RE: Foley Beach Express Access

Please find attached the proposed amendments and additions to the Access Management Plan (AMP) for the Foley-Beach Express dated May 1999.

FOLEY — BEACH EXPRESS
TYPICAL CROSS-OVER ACCESS UNIT
FOR 200' RIGHT OF WAY
EXHIBIT D

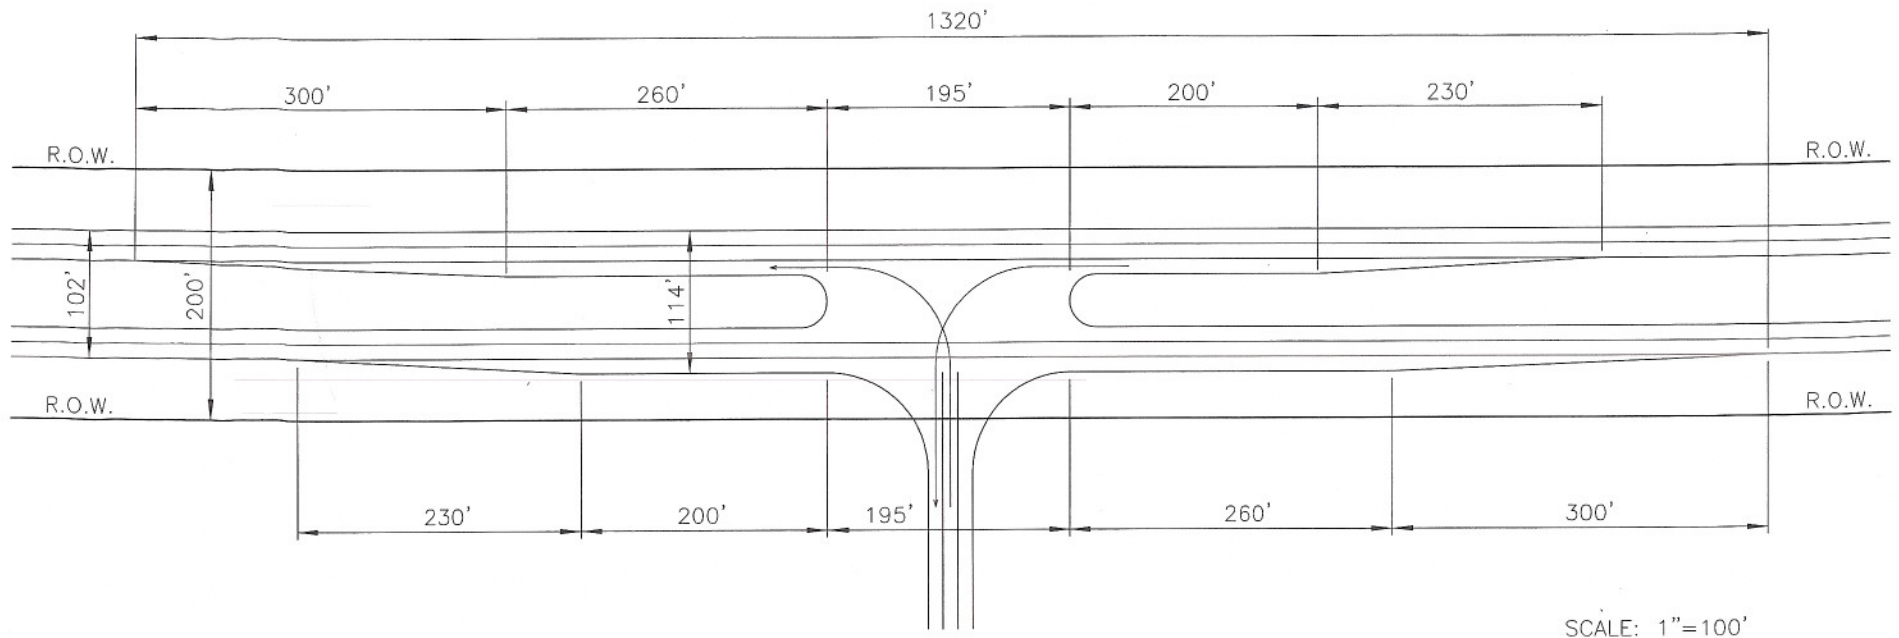
The proposed amendments involve modifications to existing Exhibits D & E, as well as, a proposed addition of an Exhibit G to the AMP for a dual cross-over access unit for a 150' right-of-way. The modifications to Exhibit D & E address the verbiage of the AMP in Section III, Item A, Note 4 that states, "An access unit consists of a driveway opening, an acceleration lane and a deceleration lane. The access unit must be contained within the property's frontage to prevent encroachment of adjoining properties access unit." When evaluating Exhibits D & E, the total required length to build the acceleration lane, deceleration lane and driveway will require 1,795 LF, which violates the ¼ mile (1,320 LF) length defined as an Access Unit and will encroach upon other property owner's frontage. To ensure that Exhibits D & E do not exceed a length of ¼ mile (1,320 LF), Hutchinson, Moore & Rauch, LLC proposes that the existing acceleration lane lengths (500 LF) be reduced to match those of existing Exhibit C in the AMP. Exhibit C requires an acceleration lane length of 260 LF (not including taper length), and when applied to Exhibits D & E will reduce their overall length to 1,320 LF. Please see the attached proposed amendments to Exhibits D & E in Appendices 1 and 2, respectively.

FOLEY — BEACH EXPRESS
 TYPICAL DUAL CROSS-OVER ACCESS UNIT
 FOR 150' RIGHT OF WAY
 EXHIBIT G

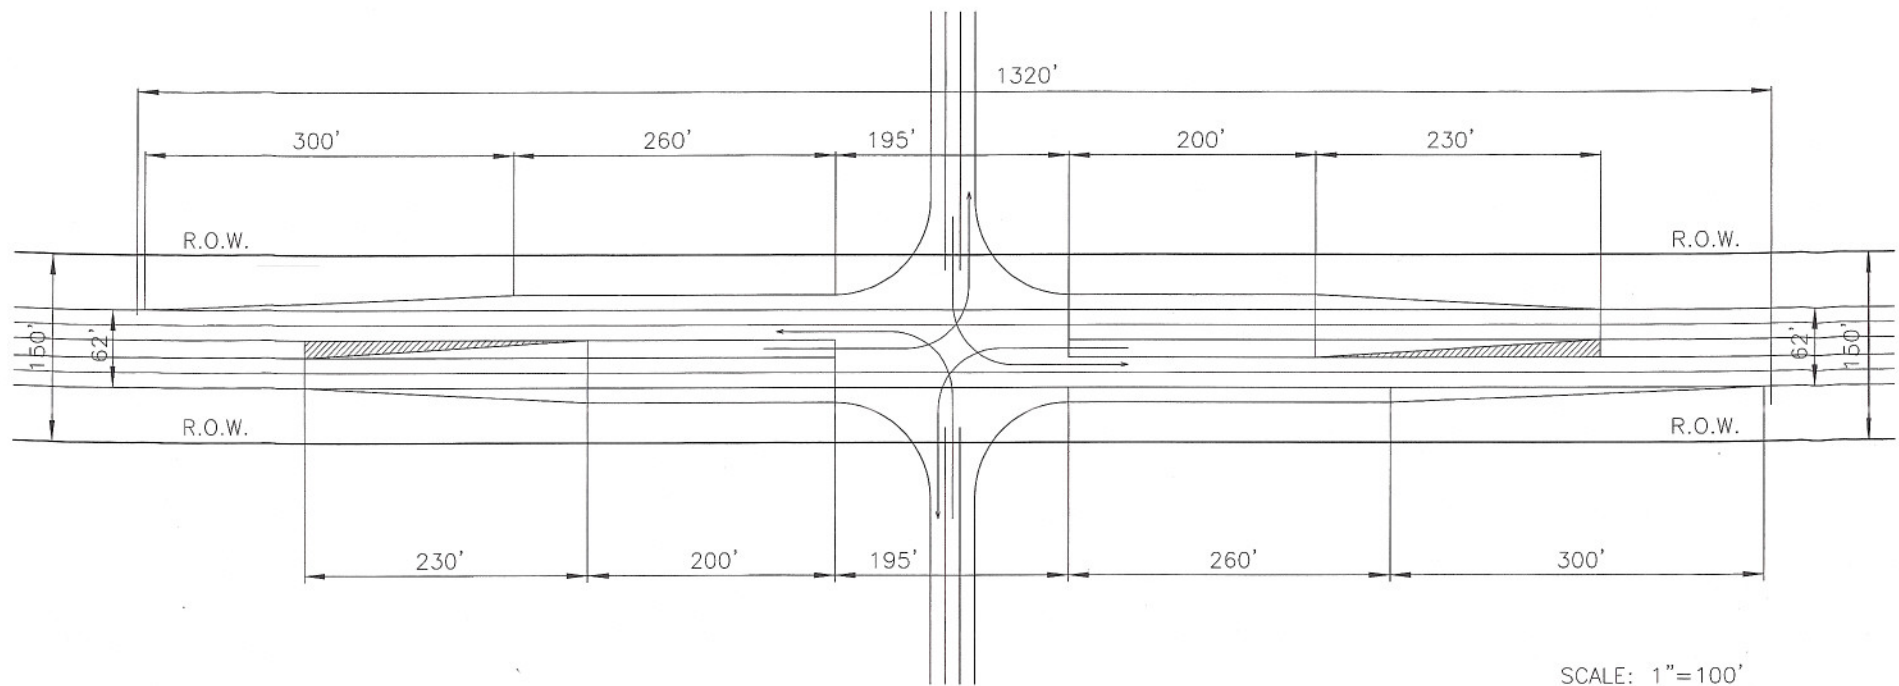
The proposed addition of Exhibit G to the AMP is for a dual access unit on 150' ROW (Appendix 3). Exhibit G will be similar to Exhibit C, however, Exhibit G will not have acceleration lanes for left turn movements onto the Foley Beach Express (FBE) from the access driveways/roads. The reasoning for this is the 150' ROW zones are 5-lane wide undivided roads that would create conflict areas where there would be no barrier between cars driving in the acceleration lanes and cars sitting in the center deceleration (left turn) lanes of the FBE. The design of Exhibit G has acceleration lanes and tapers for right turns onto the FBE from the access driveways, deceleration lanes and tapers for right turns off the FBE onto the access driveways and deceleration lanes and tapers for left turns off the FBE onto the access driveways.
